ULDR 47-21 Revisions Stakeholder Meeting

March 18, 2022

Goal of Meeting

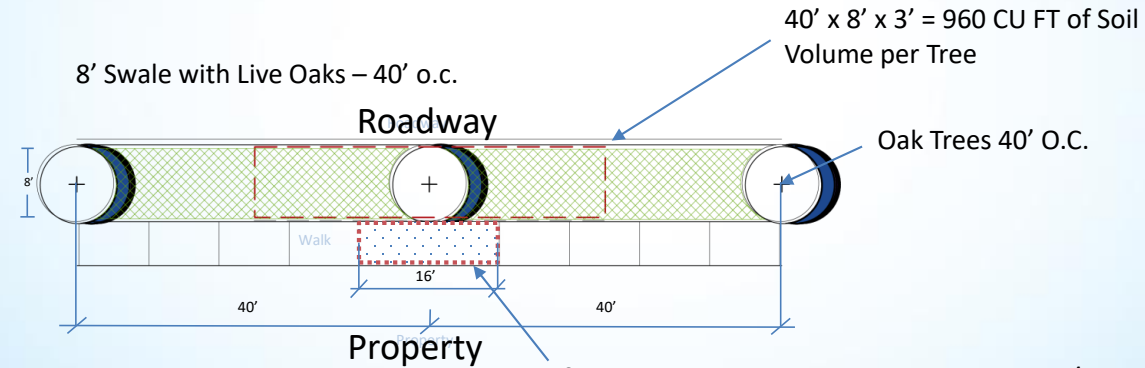
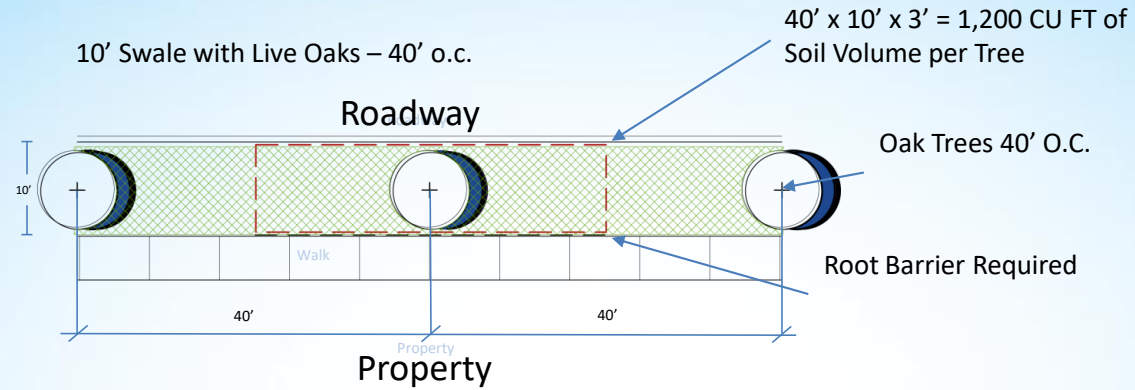
- **Concern:** Proposed ordinance increases the number of trees required in some cases

Response: The number of required trees has not increased in any of the zoning districts or categories. They all stay the same, except that the required number of street trees has actually been reduced because the drive ways can be subtracted.

Modular Suspended Pavement Cost

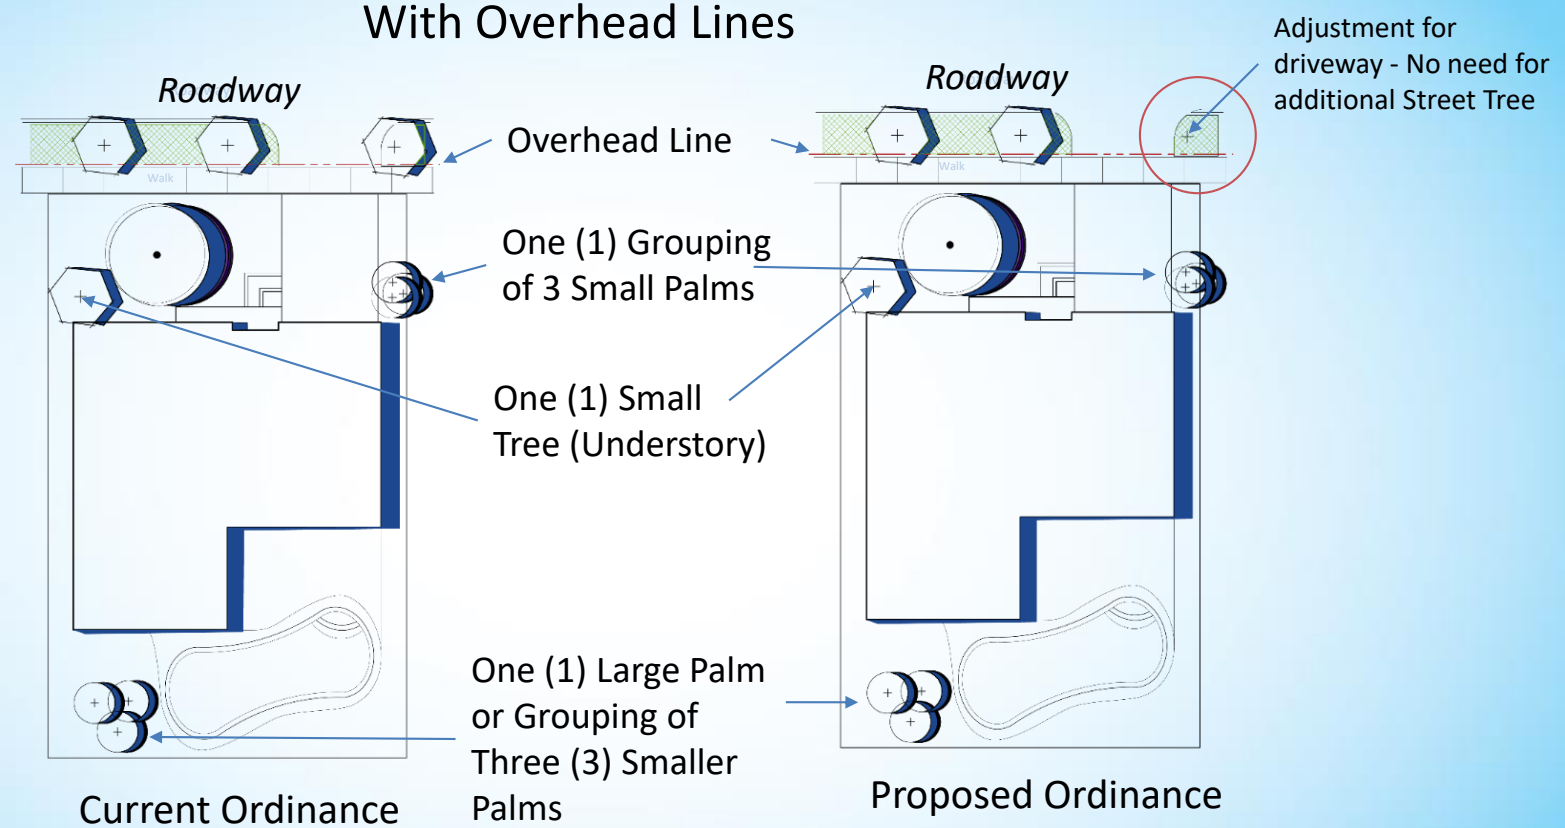
- **Concern:** Proposed ordinance requires the installation of structural soils and modular suspended pavement systems, which will dramatically increase costs for builders/developers

Example: 9' x 18' island with a large tree

**Net cost: \$5,659.33 or
\$7,916.99**
